# UNITED STATES PATENT AND TRADEMARK OFFICE

APPLICATION NO.	FILING DATE	FIRST NAMED INVENTOR	ATTORNEY DOCKET NO.	CONFIRMATION NO.
10/761,196	01/22/2004	Tian-Yuan Lai	LAIT 3004/EM	2339
23364	7590	10/19/2005	EXAMINER	
BACON & THOMAS, PLLC 625 SLATERS LANE FOURTH FLOOR ALEXANDRIA, VA 22314			CHANDRAN, BIJU INDIRA	
			ART UNIT	PAPER NUMBER
			2835

<b>Office Action Summary</b>	<b>Application No.</b> 10/761,196	<b>Applicant(s)</b> LAI, TIAN-YUAN	
	<b>Examiner</b> Biju Chandran	<b>Art Unit</b> 2835

FIG. 3

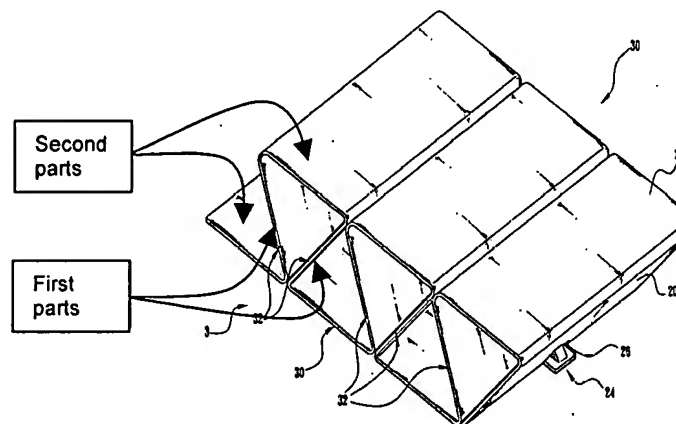
2. Claim 1 rejected under 35 U.S.C. 112, second paragraph, as being indefinite for failing to particularly point out and distinctly claim the subject matter which applicant regards as the invention. Applicant claims

"....wherein any one of said second part is disposed between any two of

said first parts,...". As the attached figure illustrates (applicant's figure 3), this is not met in the applicant's invention.

5. The drawings are objected to under 37 CFR 1.83(a) because they fail to show the heat dissipating device made up of units, each composed of two parallel plates 30 and two supporting plates 32 as described in page 4, lines 7-9 of the specification. The figures indicate a continuous structure.
6. Figure 4 does not appear to be a sectional view of the embodiment shown in Figure 5.
